# Access Compliance Report

## Public Rights-of-Way

### (Curb Ramps)

Intersection ID: 17009	Main Street: N_WENDOVER_RD	Cross Street: RANDOLPH_RD	Location: SW
ADA ID: 5AD5EC7C0B41	Ramp Type: Perp	Initial Pass/Fail: Fail	Overall Compliance: No
Codes/Mitigation Info/Possible Solution			Severity Score: 10
			Field Measurements/Component Compliance

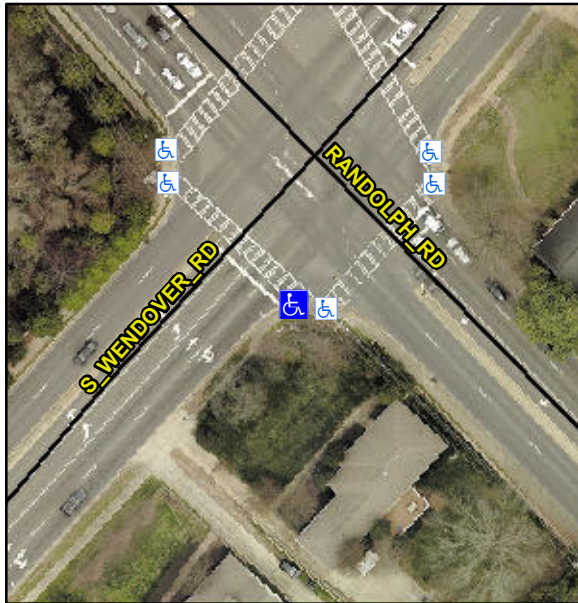
**R304.5.1, R304.5.3**

Compliance	Description	Data	Compliance	Description	Data
N/A	Ramp Length (in)	61.0	Yes	Ramp Slope (%)	6.9
No	Ramp Width (in)	42.0	No	Ramp XSlope (%)	3.0
N/A	Flare Type LT	N/A	N/A	Flare Type RT	N/A
N/A	Flare Slope LT (%)	N/A	N/A	Flare Slope RT (%)	N/A
N/A	Flare Traversable LT?	N/A	N/A	Flare Traversable RT?	N/A
N/A	Landing Length (in)	N/A	N/A	DWS Provided?	N/A
N/A	Landing Width (in)	N/A	N/A	DWS Contrast?	N/A
N/A	Landing Slope (%)	N/A	N/A	DWS Length (in)	N/A
N/A	Landing X Slope (%)	N/A	N/A	DWS Full Width?	N/A
N/A	Landing Curb? (Y/N)	N/A	N/A	DWS Offset (in)	N/A
N/A	Shared Landing?	N/A			
N/A	Gutter Ponding?	N/A	N/A	Gutter Slope (%)	N/A
N/A	Gutter Lip Ht (in)	N/A	N/A	Gutter X Slope (%)	N/A
N/A	Painted X Walk1?	Yes	N/A	Painted X Walk2?	N/A
	X Walk 1 Direction	To NW		X Walk 2 Direction	N/A
N/A	X Walk 1 Width (in)	112.0	N/A	X Walk 2 Width (in)	N/A
	X Walk 1 Slope (%)	5.5		X Walk 2 Slope (%)	N/A
	X Walk 1 X Slope (%)	0.9		X Walk 2 X Slope (%)	N/A

**Remove & Replace Entire Ramp.**
